Project	IEEE 802.16 Broadband Wireless Access Working Group < http://ieee802.org/16 >	
Title	Service Primitives for Location Update	
Date Submitted	2005-07-20	
Source(s)	Yun Won Chung, PhD Jee Hyeon Na, Sang Ho Lee, PhD ETRI, 161, Gajeong-dong, Yuseong-gu, Daejeon, 305-700, Korea	yun.chung@etri.re.kr jhna@etri.re.kr leesh@etri.re.kr Voice: +82-42-860-5244 Fax: +82-42-861-1966
Re:	Call for Comment on P802.16g Baseline Document	
Abstract	This contribution proposes service primitives for location update.	
Purpose	The document should be considered during the resolution of comments on the baseline document.	
Notice	This document has been prepared to assist IEEE 802.16. It is offered as a basis for discussion and is not binding on the contributing individual(s) or organization(s). The material in this document is subject to change in form and content after further study. The contributor(s) reserve(s) the right to add, amend or withdraw material contained herein.

Service Primitives for Location Update

[Modify section 14.5.9.3 as follow]

Fig. 2 - Location Update Primitives

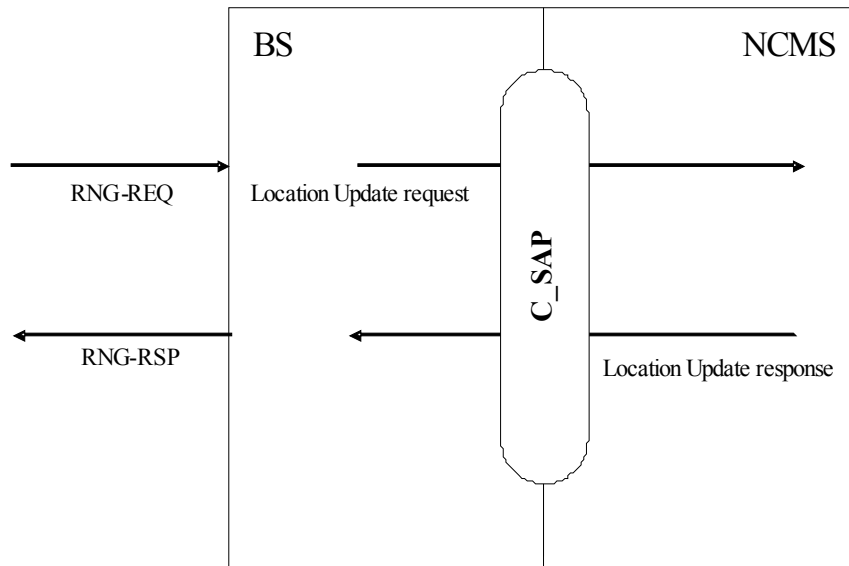
Figure 2 shows service primitives for Location Update between a BS and an NCMS.
